## **NEMA Comments on Final Draft of Energy Star Technical Specification for Luminaires** **January 14, 2011**

Thank you for the opportunity to provide the following comments on the Final Draft of the Energy Star technical specification for Luminaires, Version 1.0, on behalf of members of the Lamp, Ballast, Luminaire and Solid State Lighting Sections of the National Electrical Manufacturers Association (NEMA).

**Figure 7-21.** Examples of cove luminaires: (a) cove forming luminaire with biaxial fluorescent lamp, (b) and (c) cove forming luminaires with linear fluorescent lamps, and (d) fluorescent lamp strip luminaire with asymmetric reflector for mounting in a cove.

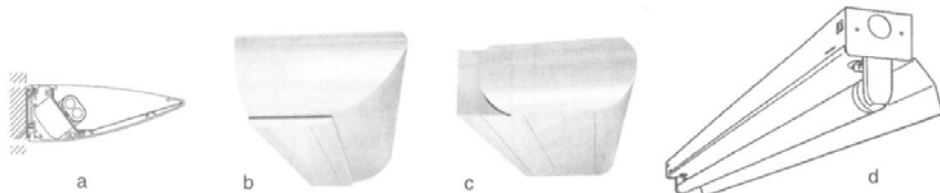
Separately, the **Zonal Lumen Density Requirement** for Cove Mount lighting doesn't allow for standard industry practice. The requirement is "35% of total lumens within the 30-60° zone from the zenith". This narrow (30°) beam angle would disqualify a large percentage of cove lights, including some of the cove light examples described and illustrated in the IES Handbook (9<sup>th</sup> edition, pages 7-11 and 7-12), excerpted below, and some Energy Star-approved cove lights which are advertised to have a "wide beam angle".

We recommend that cove lighting be allowed to have wider beam angles. For example, a luminaire producing 65% of its lumens in a 120° symmetric beam (i.e., within 60° of the center line) should be allowed.

### 3500 K, wide beam

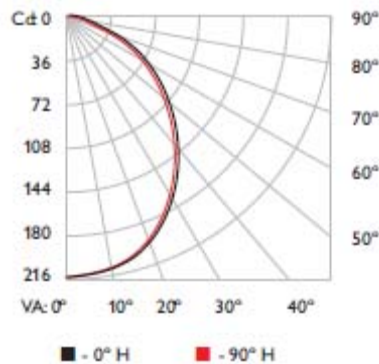
*Note: This Energy-Star-rated cove fixture would not pass the draft Luminaire requirements (and it apparently doesn't pass the existing SSL Products requirements). Only 28.4% of lumens are in +/-30° zone (60° total angle), compared to 35% required in a 30° angle.*
